SUBJECT: Transmittal of Revised Responses to AP1000 DSER Open Items

AP1000 Design Certification Review
Draft Safety Evaluation Report Open Item Non-Proprietary Responses

DSER Open Item Number: 3.6.3.4-2 Addendum 1 Revision 2

Current Figure 5.4-7 Normal Residual Heat Removal System Piping and Instrument Diagram

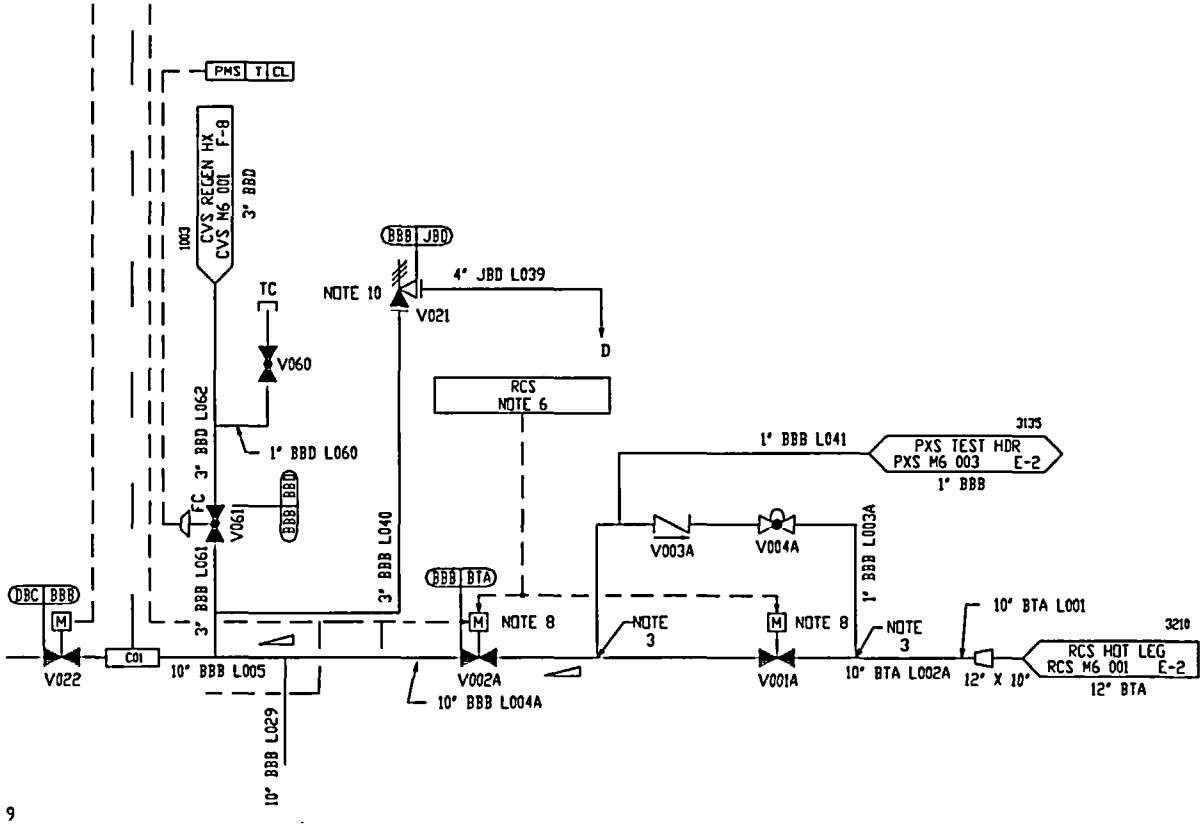
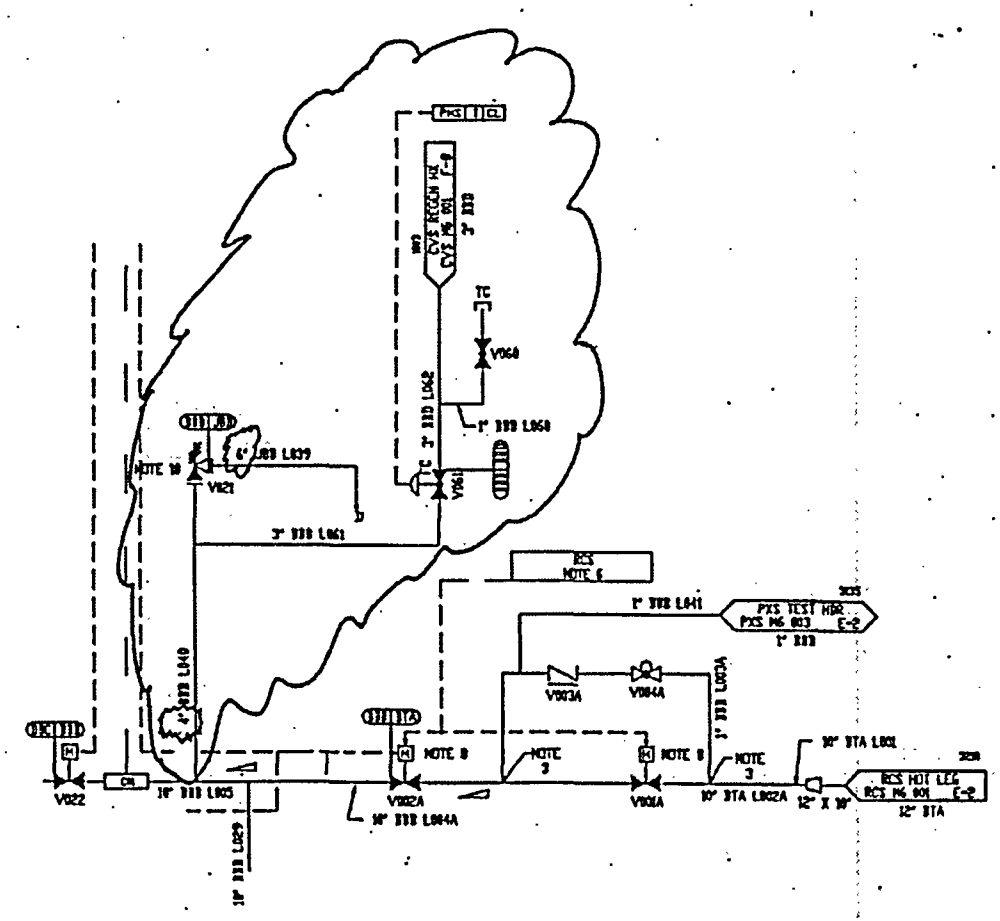
Revised Figure 5.4-7 Normal Residual Heat Removal System Piping and Instrument Diagram

Figure 19E.4.8-8

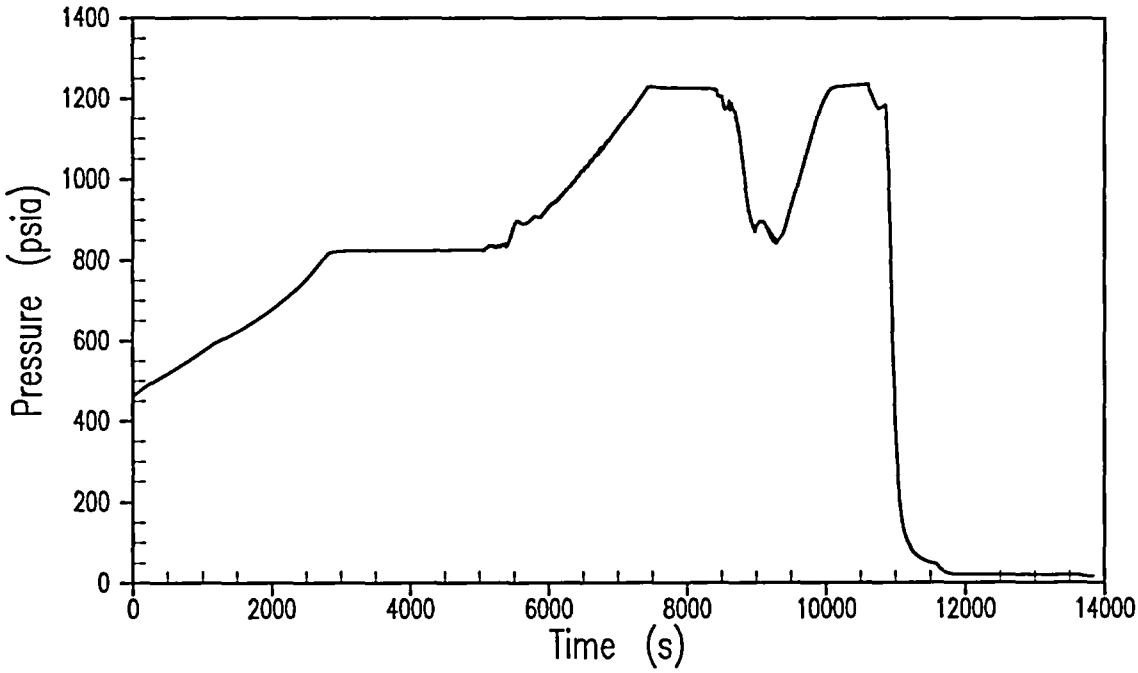
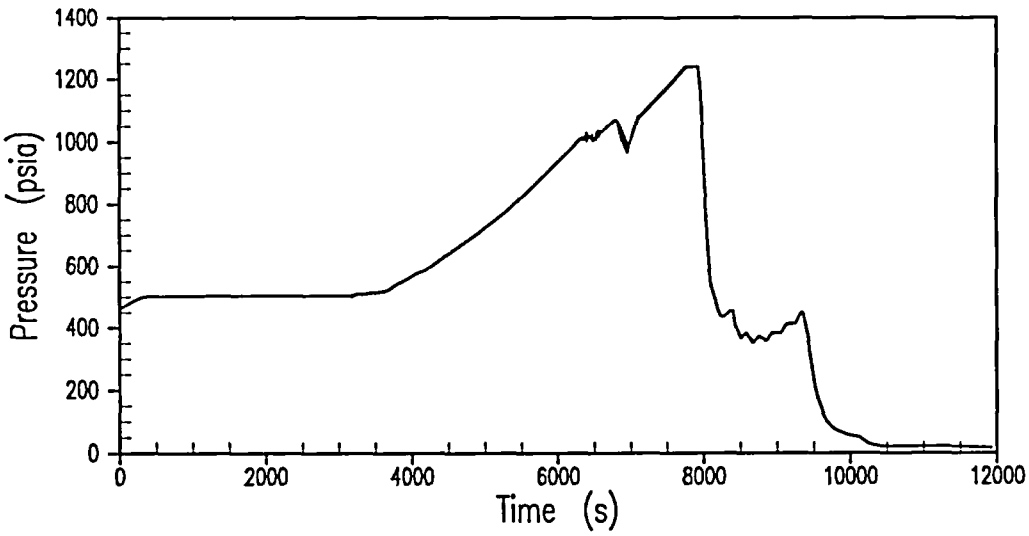
Revised Figure 19E.4.8-8

Figure 19E.4.8-19

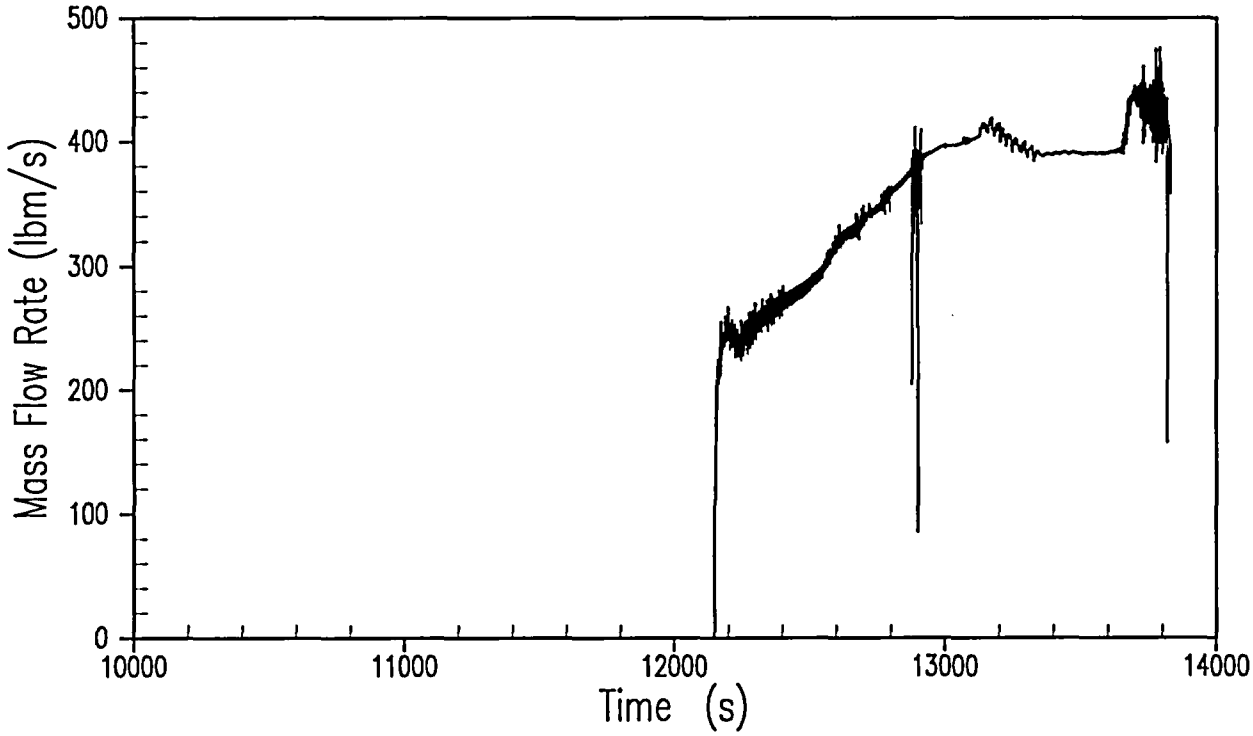
at ~~11,900~~**10,225** seconds. As noted previously, it is assumed that one of the fourth-stage paths is out of service and one path is assumed to fail as the single active failure. The vapor and liquid flow through the fourth-stage ADS paths (Figures 19E.4.8-17 and 19E.4.8-18) further reduces the pressure to the point where IRWST injection begins at approximately ~~12,200~~**10,700** seconds (Figure 19E.4.8-19).

Figure 19E.4.8-21

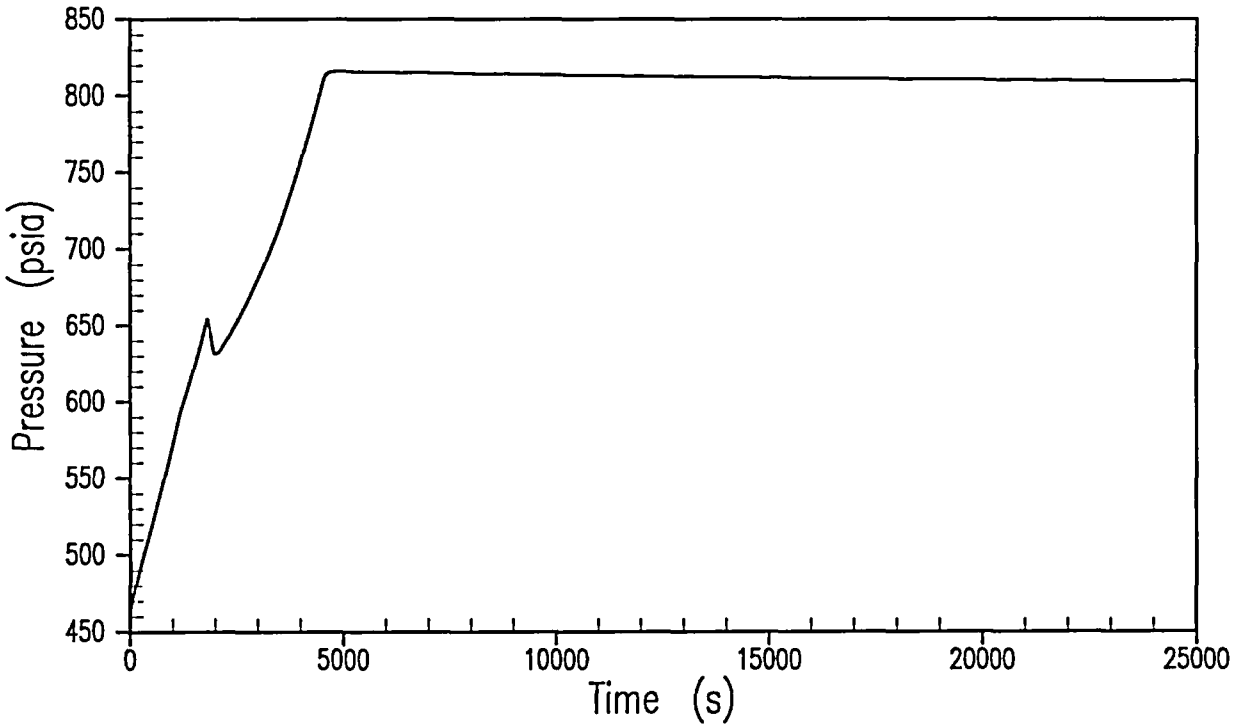
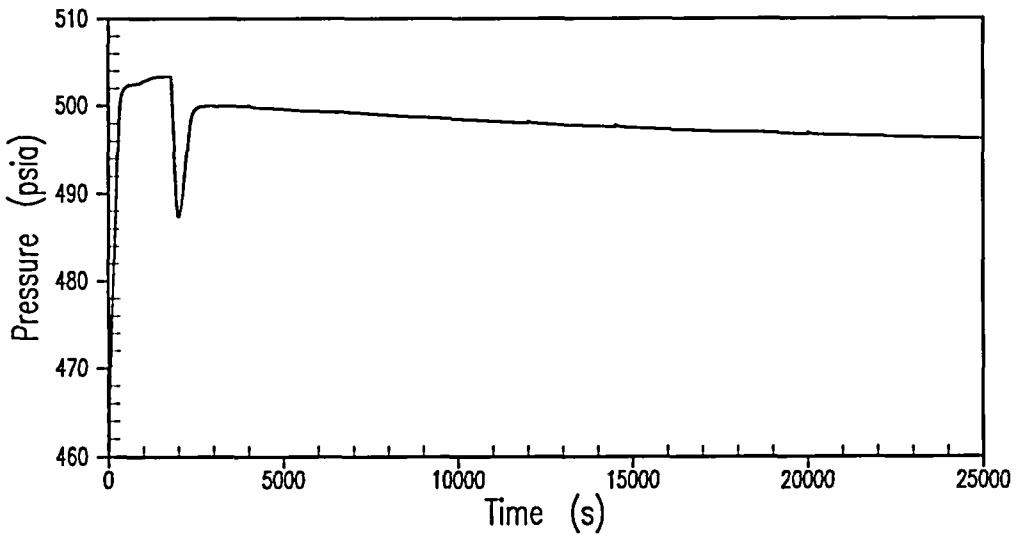
If operator action occurs after 1800 seconds, the CMT and PRHR isolation valves would open. Initially, the decay heat is greater than the PRHR capacity and the RCS pressure increases to the RNS safety valve setpoint (Figure 19E.4.8-21). At this time, **RCS** ~~a small amount of~~ inventory is vented through the valve (Figure 19E.4.8-22). Eventually, the decay heat matches the PRHR capacity (Figure 19E.4.8-42) and the RCS pressure decreases slowly to the valve setpoint. For this case, ~~no significant loss of inventory occurs and~~ the ADS is not actuated. The sequence of events for this case is also shown in Table 19E.4.8-2.

Revised Figure 19E.4.8-21

Figure 19E.4.8-23

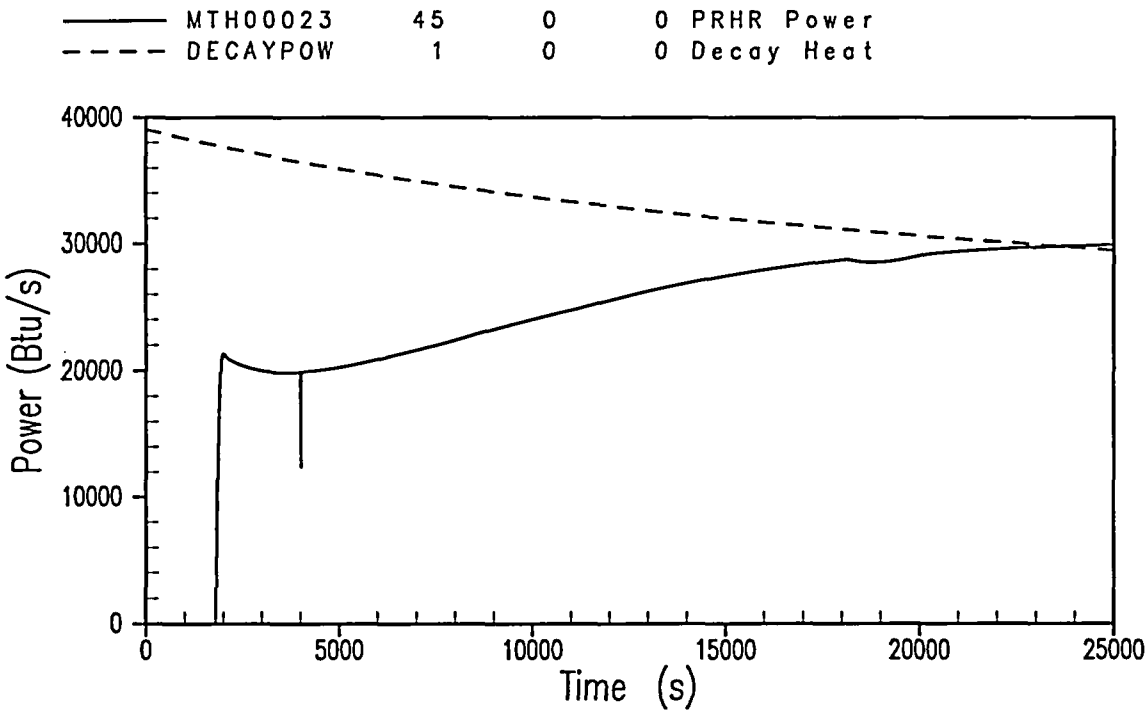
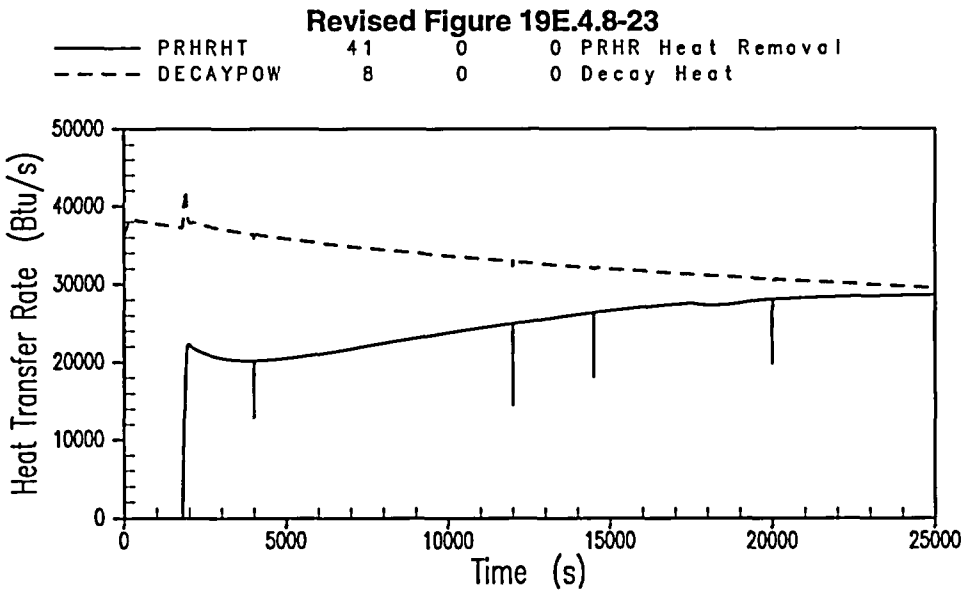
Revised Figure 19E.4.8-23
